COMHAIRLE CONTAE ÁTHA CLIATH THEAS SOUTH DUBLIN COUNTY COUNCIL

<u>Chief Executive's Report on Public Consultation for Proposed Social and Affordable Purchase</u>

<u>Housing Development of 118 New Homes in Clonburris SDZ (Canal Extension Development Area)</u>

Planning Report in Accordance with Section 179 of the Planning and Development Act 2000 (as amended) and Part 8 of the Planning and Development Regulations 2001 (as amended)

Fig.8: Extract from SDZ- Overall Movement Concept diagram

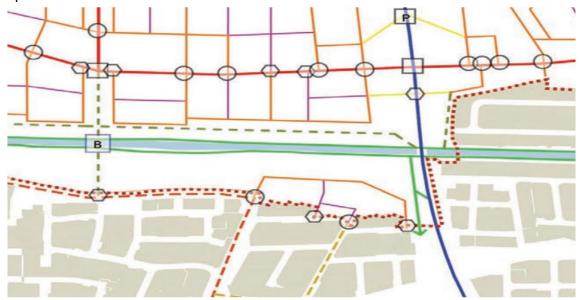
Submissions contended that there should be no pedestrian or vehicular access to Ashwood to or from the new development, including objections to the proposed walkways connecting the new estate to existing Ashwood estate, suggesting that access to local amenities can be easily achieved with pedestrian routes out by and along Bawnogue Road. Alternatively, it is proposed in some submissions that pedestrian entrances to Ashwood should be fenced off from the proposed development and that any remaining pedestrian access points should have adequate lighting without creating any negative impacts for local wildlife and should consider the installation of CCTV.

Suggested alternative vehicular access included proposed vehicle access exclusively from Fonthill Road or splitting the traffic management of the development with half the development having access from Bawnogue Road and half having access from Fonthill Road with no through traffic from Bawnogue Road to Fonthill Road permitted.

The existing two connections to the Grand Canal towpath have been retained and linked with the proposed development. The existing connection to Fonthill Road and cycle path has been improved through a direct connection to Ashwood Drive and there are also two further connections through the development from Ashwood Road linking to the canal and Fonthill Road. The proposed local vehicular, pedestrian and cycle link has been identified with the SDZ via Ashwood Estate. Due to existing trees at the proposed location the vehicular link is not proposed but pedestrian and cyclist links are proposed to comply with the SDZ requirements. Further green and blue pedestrian and cyclist connections can be progressed as subsequent phases of the SDZ are brought forward for development.

The development includes a pedestrian connection with Ashwood in accordance with the SDZ requirement and objectives to prioritise pedestrian and cyclist movement with the creation of a network of routes that maximises choice. The SDZ scheme specifies that there shall be no barriers to pedestrian or cyclist movement between residential developments and the proposed development is designed accordingly. The proposed access via the Bawnogue Road is identified in the SDZ as an access point to the development at Canal Extension. Access via the Fonthill Road is not considered viable due to it being a distributor road designed to minimise any disruption to vehicle movement. Where access is proposed, safety concerns are often raised because of the fast-moving/free-flowing nature of these roads and therefore it is considered that an exit from the proposed development onto this road would not be appropriate.

Fig.12: Surface water drainage

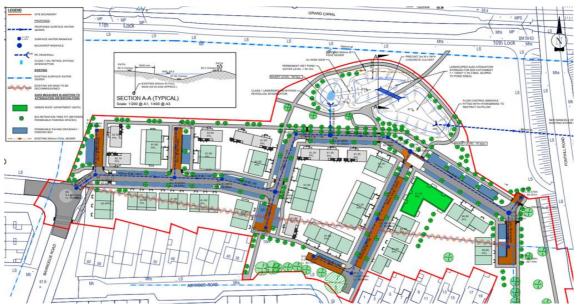
Submissions noting issues with drainage on the land for the proposed development as well as concerns about existing/future drains and impacts on existing residents' drainage and requesting clarification as to where the flood water will go from the proposed site, suggesting that the proposed attenuation pond will be insufficient given historic flooding in the area as well as increasing extreme weather events.

The drainage of the development has been designed to minimise impact on the receiving environment and surface water run-off is directed to an attenuation feature to the north of the proposed development. This will slow down rainwater run-off from the development and ensure greenfield run-off rates are maintained with respect to downstream infrastructure.

Sustainable urban drainage systems (SuDS) have been employed in the design of the scheme for rainwater management and the proposed SuDS feature on site has been regraded to provide an enhanced amenity while serving as an attenuation pond for storage, sedimentation and filtration of rainwater.
